ADDENDUM NO. 2

**IMPROVEMENTS TO BAYVIEW PARK, HIGHLAND AVENUE SIDEWALK
IMPROVEMENTS, AND IMPROVEMENTS TO THE LILLIAN GREGERMAN BANDSHELL
WAREHAM, MA**

Bid #1048

January 30, 2024

1 ADA RAMP WITH STAINLESS STEEL HANDRAIL

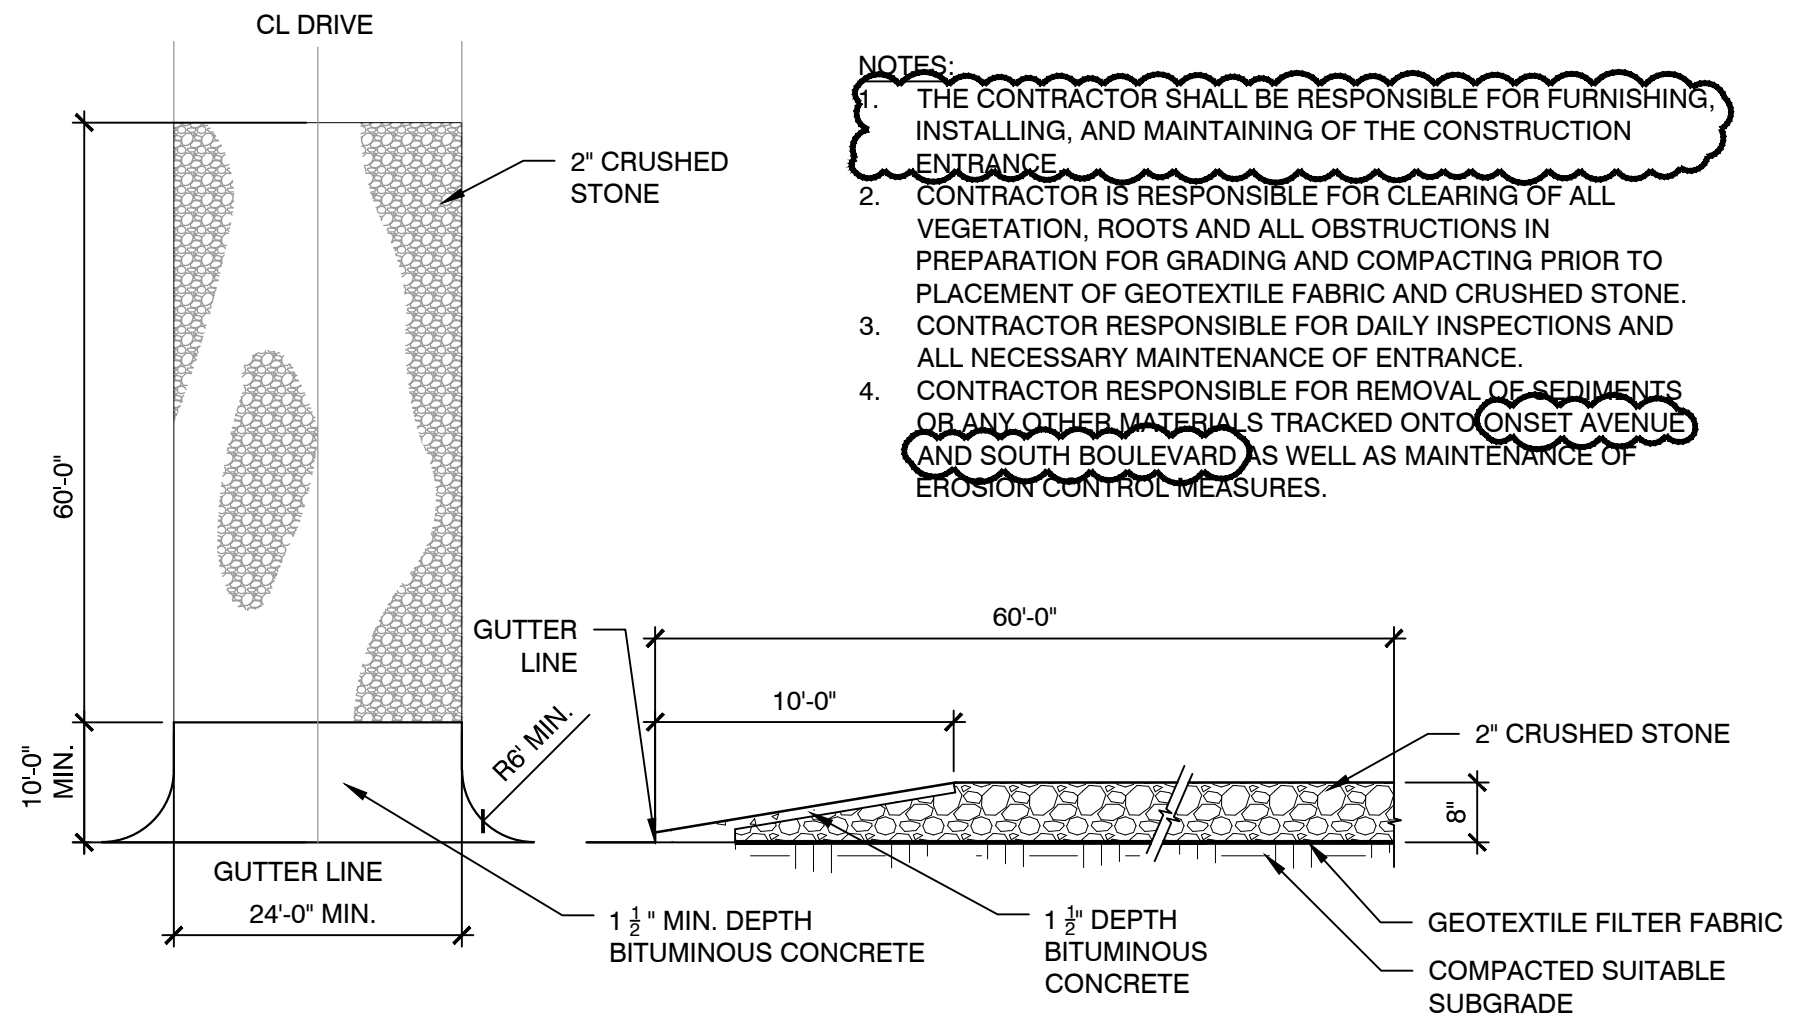
IMPROVEMENTS TO BAYVIEW PARK
REVISIONS TO THE ADA RAMP WITH STAINLESS STEEL HANDRAIL

- NOTES:**
1. ALL HANDRAILS SHALL BE STAINLESS STEEL, BRUSHED FINISH.
 2. HANDRAILS SHALL BE CORE DRILLED AND GROUTED.
 3. ALL WELDS SHALL BE GROUND DOWN CLEAN AND SMOOTH.
 4. ALL DIMENSIONS SHALL BE FIELD VERIFIED AND ADJUSTED AS NEEDED PRIOR TO FABRICATION.
 5. CONTRACTOR SHALL SUBMIT LARGE SCALE SHOP DRAWINGS OF HANDRAILS PRIOR TO FABRICATION.
